To: T10 Technical Committee  
From: Timothy Høglund, LSI Logic  
Date: 12 January 2004  
Subject: T10/04-036r1 SAS-1.1: AIP clarifications and XL state transition

This proposal seeks to clarify and correct a few expander-related issues present within the current working draft of the SAS 1.1 specification:

Figure 1 — Arb Lost

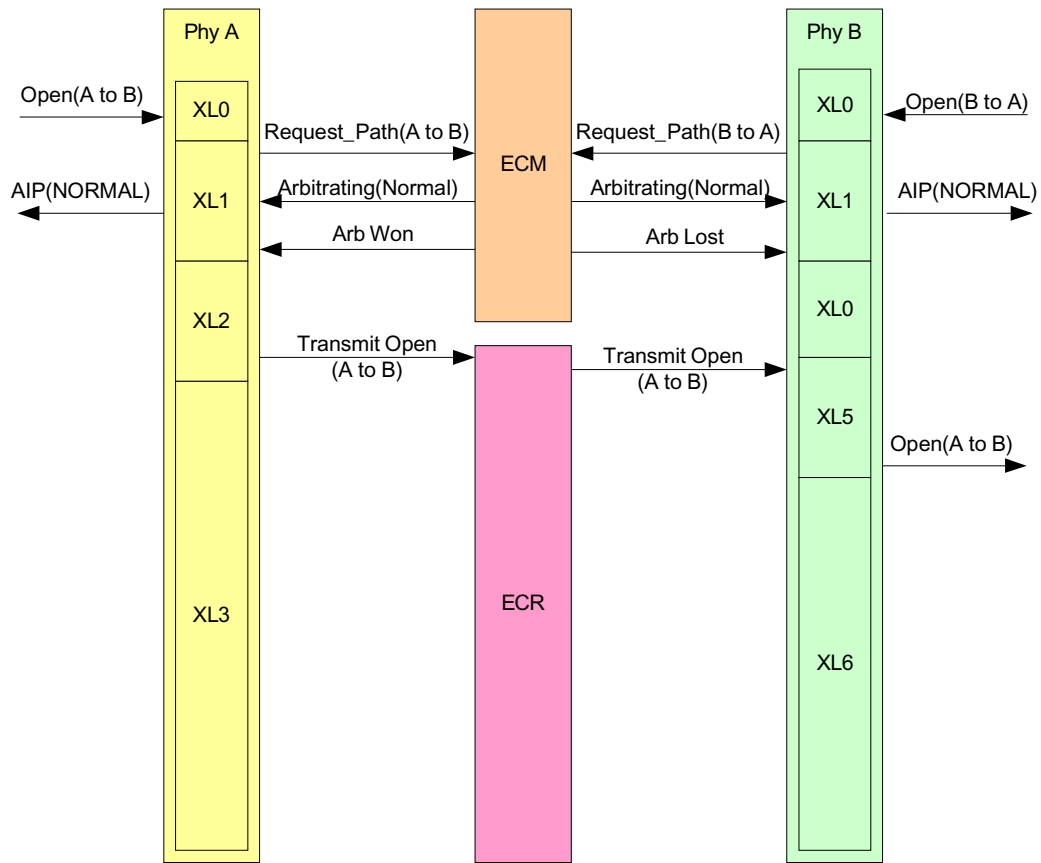
Should two expander phys arbitrate for each other at the same time, the ECM will provide an Arb Won confirmation to one and an Arb Lost confirmation to the other and both phys will properly resolve the situation.

Figure 2 — Missed Transmit Open

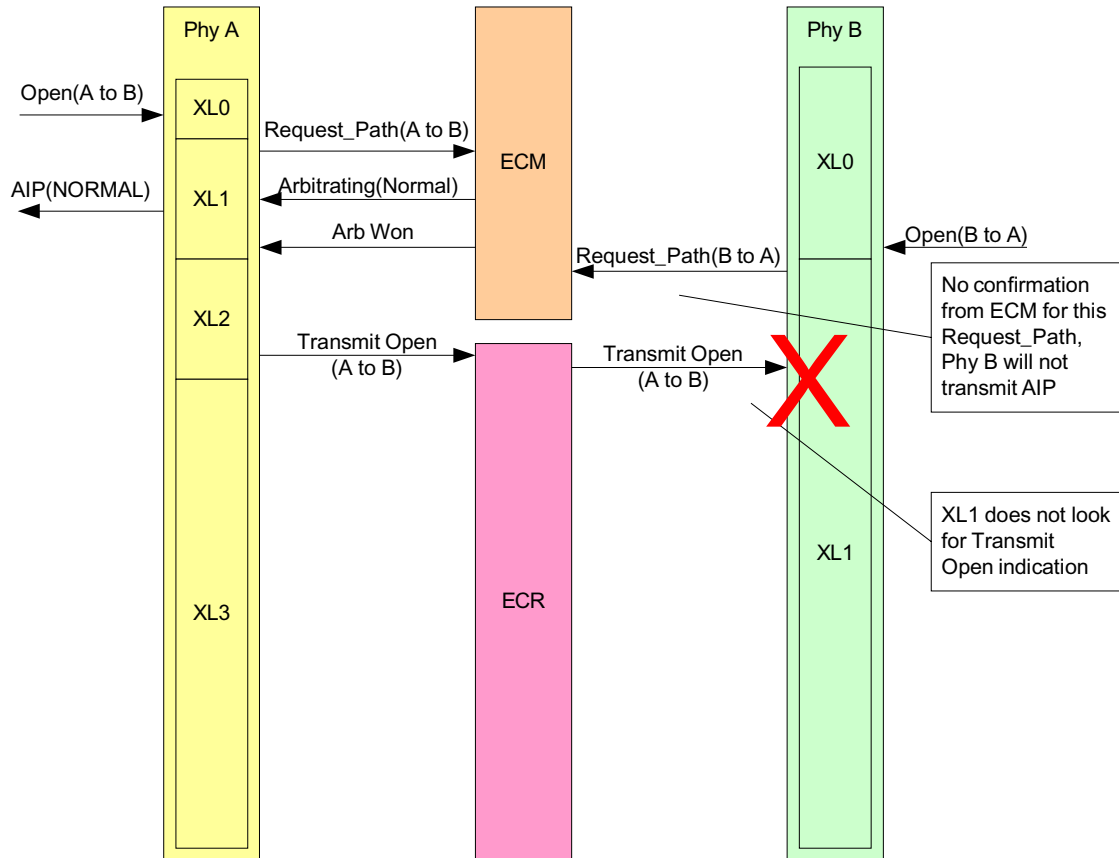
However, a window of misopportunity exists whereby if phy B arbitrates for phy A after phy A has received an Arb Won confirmation, phy B will get stuck in the XL1:Request\_Path state and not detect the Transmit Open indication from phy A.

**Figure 3 — Transmit Open Detected and Processed**

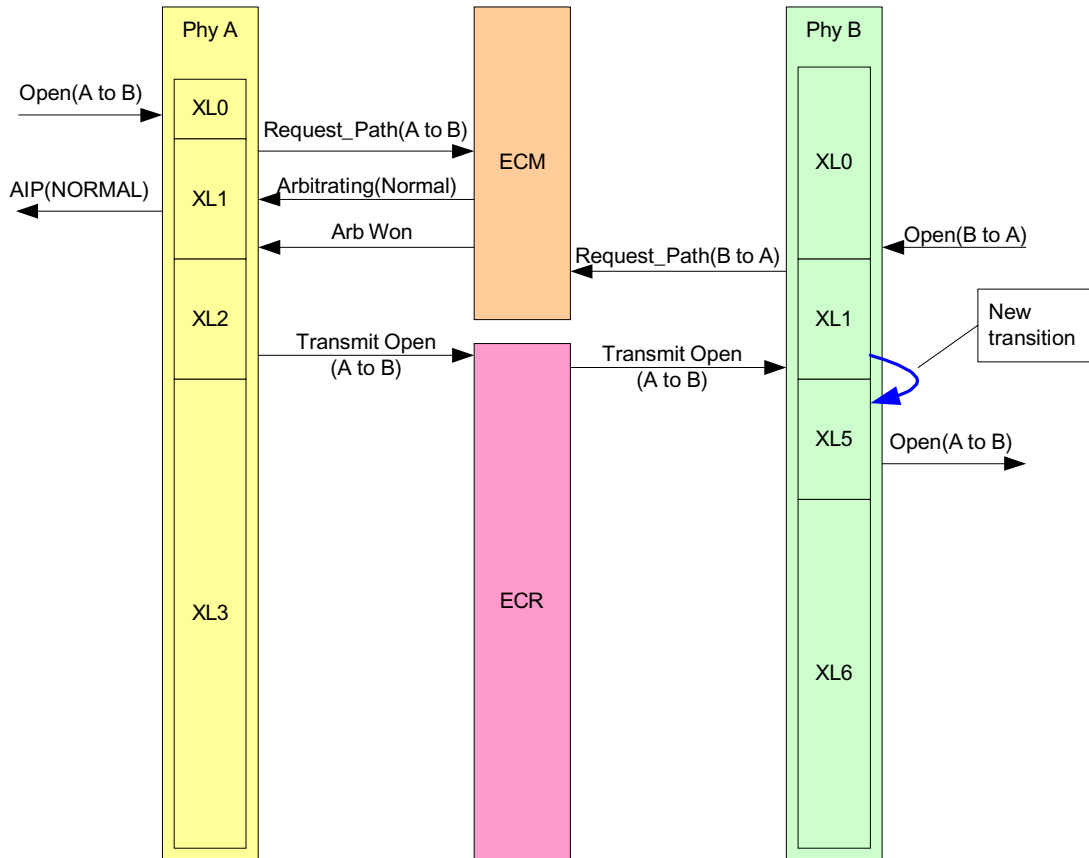
This proposal calls for the addition of a state transition from XL1:Request\_Path to XL5:Forward\_Open and the passing of an OPEN Address Frame Received argument along with this transition to properly resolve the scenario.

Figure 90 — XL (link layer for expander phys) state machine (part 1)

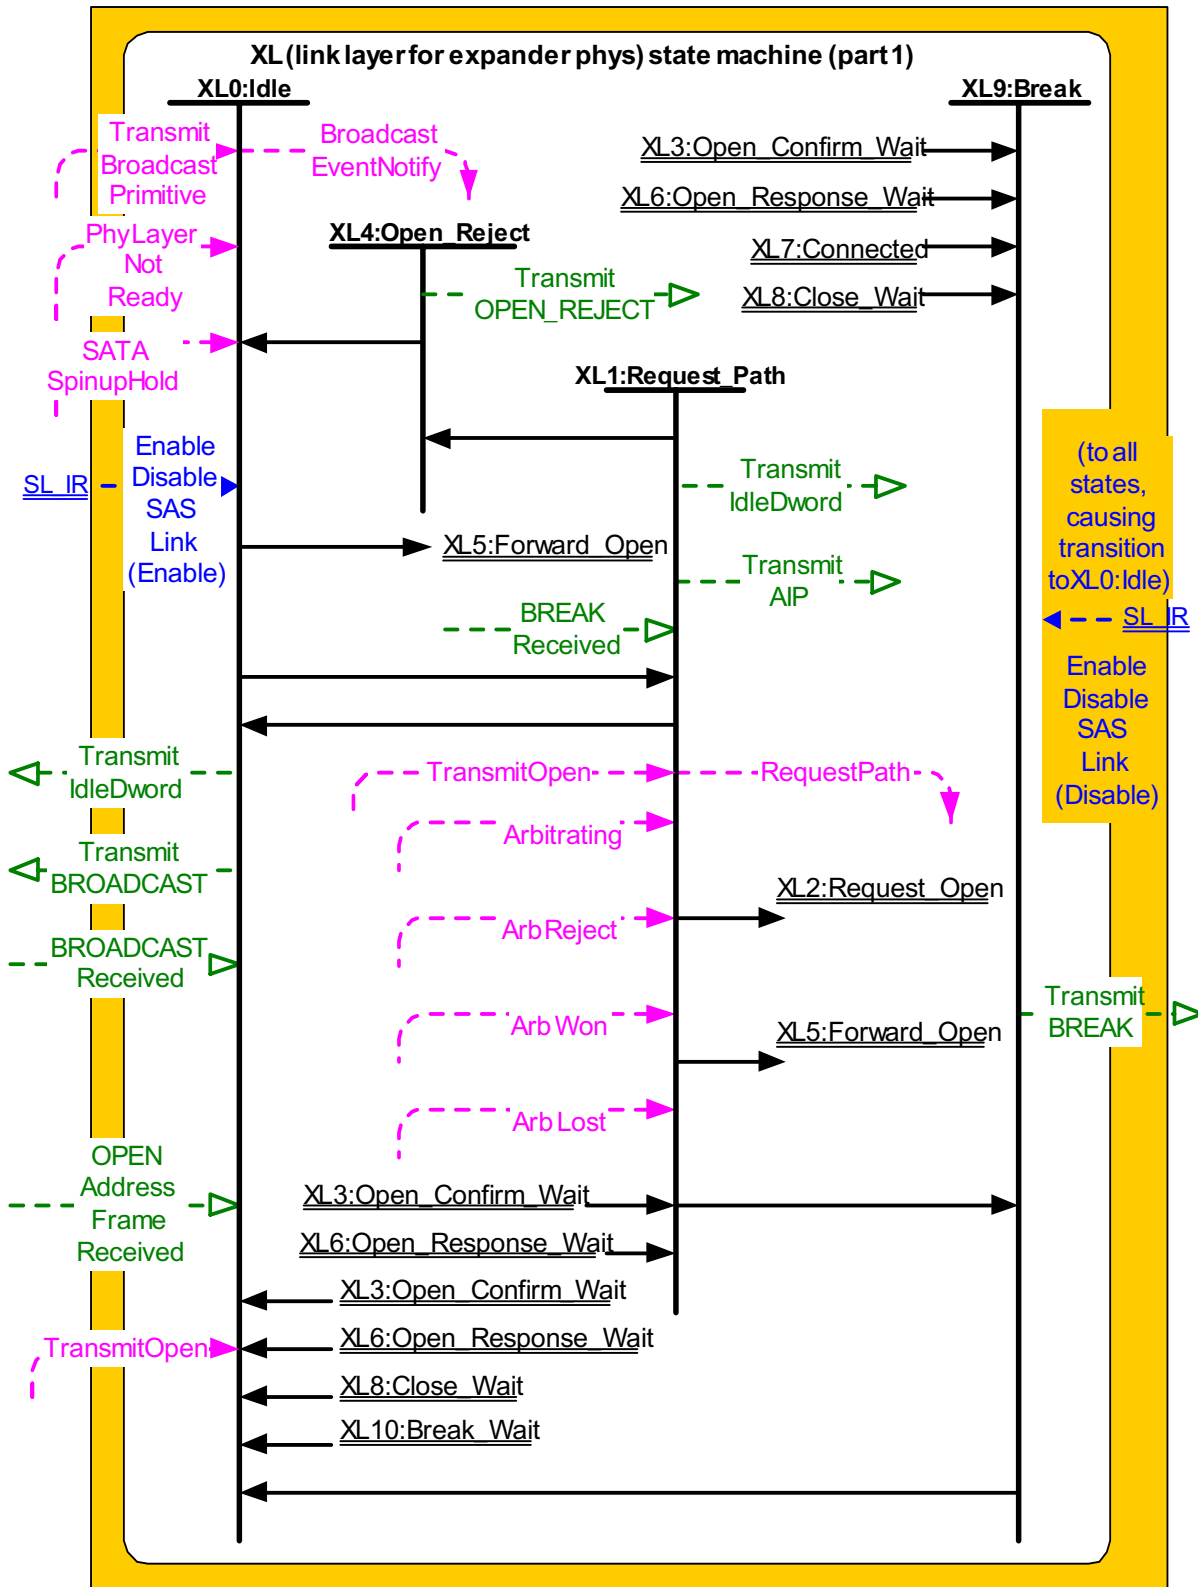
### 7.15.4.6 Transition XL1:Request\_Path to XL5:Forward\_Open

This transition shall occur if a Transmit Open indication is received and none of the following confirmations have been received:

- a) Arbitrating (Normal);
- b) Arbitrating (Waiting On Partial);
- c) Arbitrating (Blocked On Partial);
- d) Arbitrating (Waiting On Connection);
- e) Arb Won;
- f) Arb Lost;
- g) Arb Reject (No Destination);
- h) Arb Reject (Bad Destination);
- i) Arb Reject (Bad Connection Rate); or
- j) Arb Reject (Pathway Blocked).

This transition shall include an OPEN Address Frame Received argument containing the arguments received in the Transmit Open indication.
